TOWN OF PLAINFIELD DESIGN REVIEW COMMITTEE

DATE: 01-06-2026
CASE NO.: DP-25-99
Project Page: [Culvers – Gateway Drive](#)
PETITIONER: Brett Hickey of Kimley-Horn & Associates on behalf of Culvers
REQUESTED ACTIONS: Architectural and Site Design Review for a proposed drive-thru restaurant of approximately 4,550 square feet in size.
LOCATION: 5074 Gateway Drive
PARCEL SIZE: 3.46 acres +/-

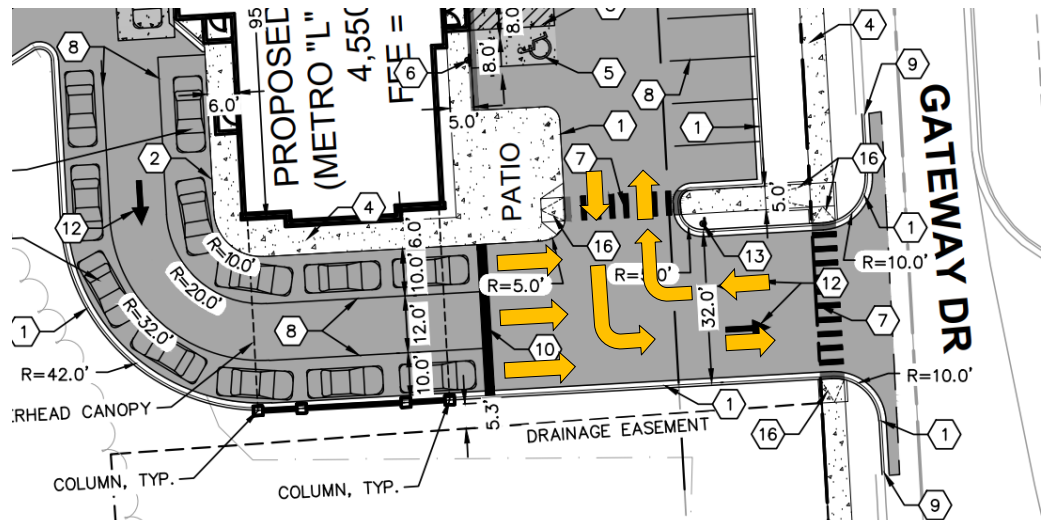
PLANNING: Item #1 – Questions have been raised by staff about whether or not the “aluminum cladding” called out as a building material in the [Architectural Elevations & Renderings](#) is a primary or accent material. The applicant, in their formal response to comments made during the Project Review Meeting, classified the aluminum cladding as an **accent** material, thus bringing 3 of their 4 elevations below the required point threshold.

In addition to the illumination beyond the property line discussed above, the applicant has included indication that “Blue LED Strip Lighting” (shown on the right) will be included on the upper trim of a majority of the building.
